Product/Trade Name:	ARTIS icono biplane, ARTIS icono floor, ARTIS pheno	EU-SRN	DE-MF-000006122
Model Number:	11327600, 11327700, 10849000	E-mail	advancedtherapies-fsca.team@siemens-healthineers.com
		Date	February, 2022
		Corrective Action ID	AX003/22/S, AX004/22/S

## Customer Safety Information (CSI) for Field Safety Corrective Action

**Subject: Software update of ARTIS systems with software version VE20 to VE21**

Figure 1: C-Arm position in singularity

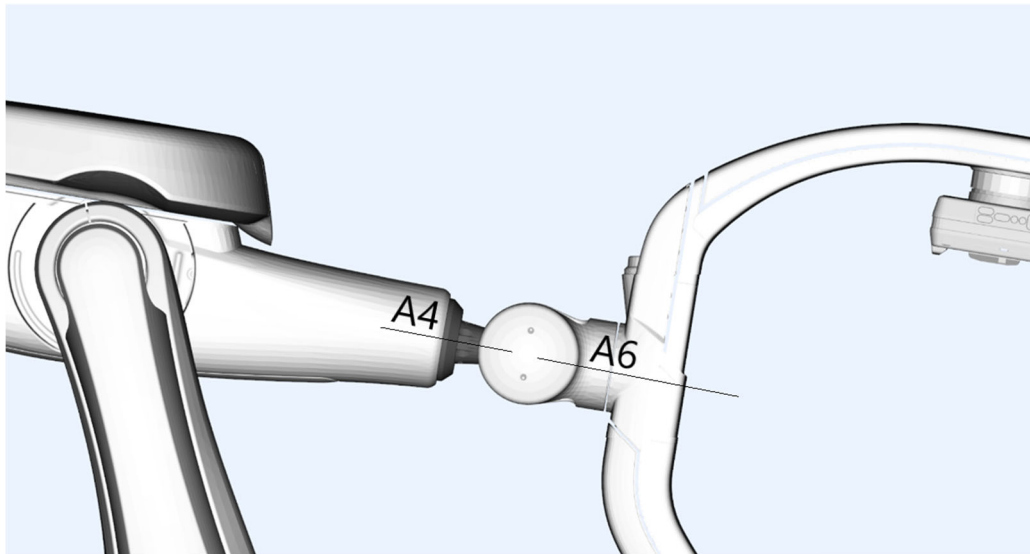
In special, clinically untypical positions of the ARTIS pheno stand (see figure 1) the robot may move into a so called singularity position, where the movement may get stopped and blocked.

If this issue occurs, all stand movements are blocked and can only be reactivated by a field service engineer. Depending on the status of the intervention, the limited functionality may not be sufficient to continue with treatment as planned. This may result in a situation where it is necessary to cancel clinical treatment or to continue treatment on an alternative system.

The issue has been identified in the field in combination with a suboptimal system adjustment only. The root cause for the blocked stand movement is a software issue.

The software will be updated.
